**Thomsons Lake Urban Development**  
**Revised South Jandakot Drainage Management Plan**  
**Ministerial Condition 2**

**Report and Recommendations**  
**of the**  
**Environmental Protection Authority**

Figure 4: Proposed urban drainage system

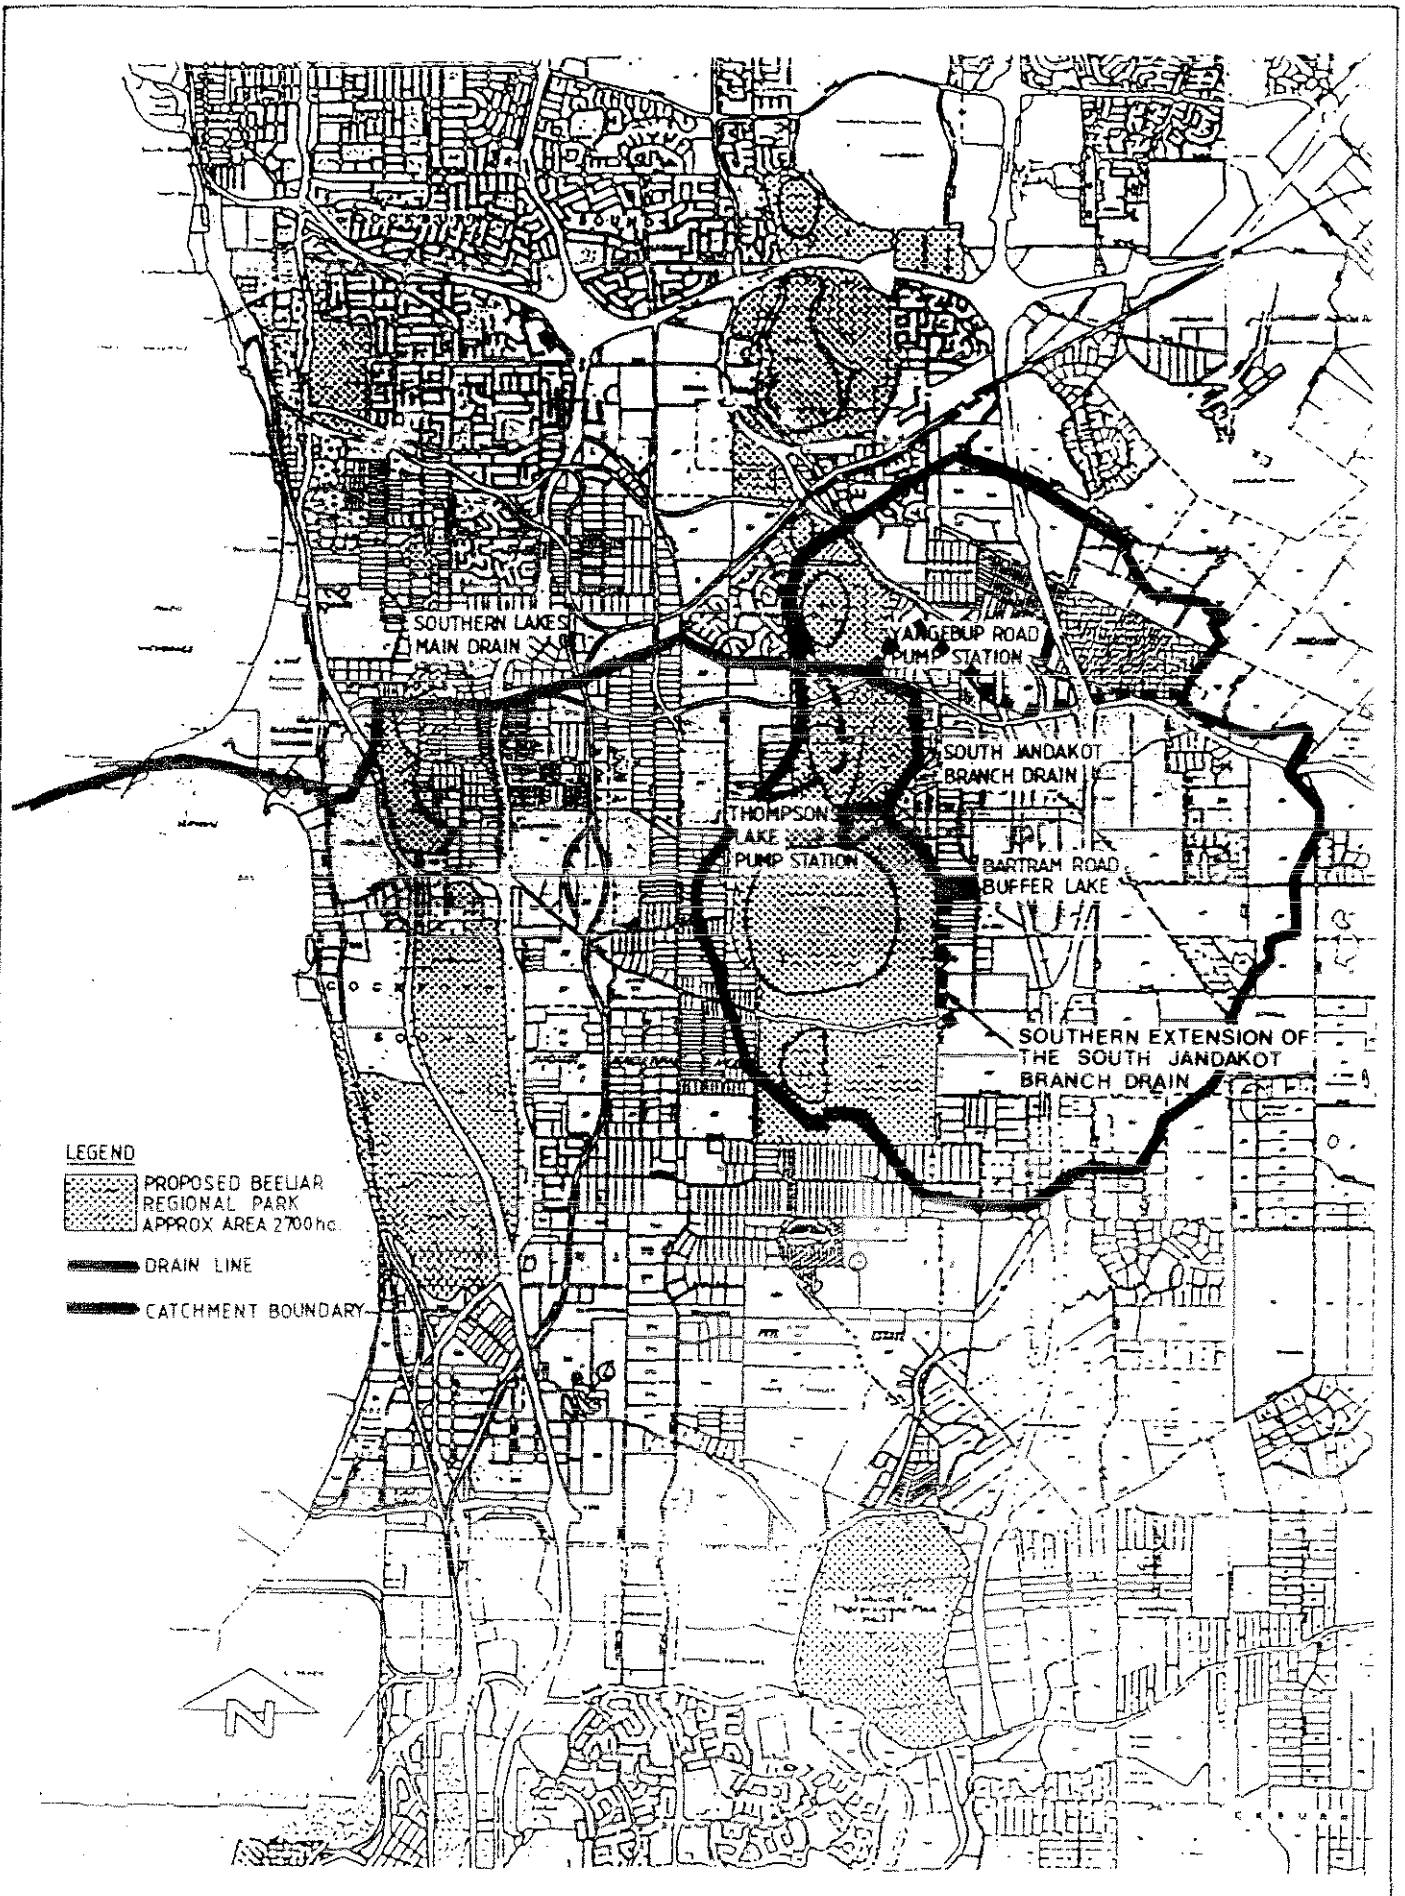
A revised Drainage Management Plan for the South Jandakot urban development was submitted by the Department of Planning and Urban Development in February 1990. The principal features of the drainage system are shown on Figure 4. The main components of the drainage system are:

- a main drainage system comprising of a pipe drain from east of Thomsons Lake to Yangebup Lake, a pump station servicing Thomsons Lake, a pump station servicing Kogolup and Yangebup Lakes jointly, and an outlet pipe from Yangebup Lake to route excess drainage water from the catchment. The major lakes would be used selectively to provide compensating storage necessary in routing the drainage from the catchment, although the main drain between Thomsons and Yangebup Lakes has been designed to enable the majority of water to be diverted past Thomsons and Kogolup Lakes, and the design of the pumping stations and outlet mains such that environmentally acceptable water levels in the major lakes could be achieved. Also, the outlet system has been developed in a manner which could provide opportunity for utilisation of the excess drainage water.
